## DA ACCESS REPORT

**PROJECT NAME** 29-33 Cessnock Road, Gillieston Heights NSW  
**PROJECT NUMBER** CA240043  
**CLIENT** Approved

REVISION	ISSUE DATE	DETAILS
DA-1	10 July 2024	Issued for DA submission
DA-2	9 September 2025	Issued on updated design

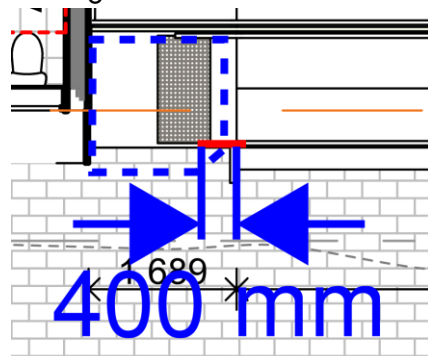
a)	For ramp ends, handrails are required to extend 300mm horizontally and turn away to the side wall or turn downwards through 180°.	AS 1428.1 7.3 i Figs. 14, 15	Amend for CC
----	---	------------------------------------	--------------

At the base of the switchback ramp, the handrail extension is to extend forward in the same direction rather than turning 90° to follow the path of travel. The ramp will therefore need to be set back at least 400mm to provide this handrail extension clear of landing dimensions:

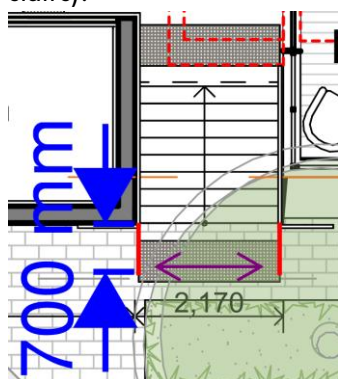
| <p>b) At the bottom of stairs, handrails are to extend one tread width in the downward angle plus 300mm horizontally. At the top they are to extend 300mm horizontally. The ends are to be turned away to the side wall or turned downwards through 180°.</p> | <p>AS 1428.1<br/>8.2 d, e<br/>Fig. 28</p> | <p>Amend for CC</p> |

At the base of the entry stairs, handrail extensions are to extend forward in the same direction rather than turning 90° to follow walls on either side. The stairs will therefore need to be set back at least 700mm (depending on the tread width) to provide handrail extensions clear of the transverse path of travel (while retaining appropriate setback for handrail extensions at the top of stairs):
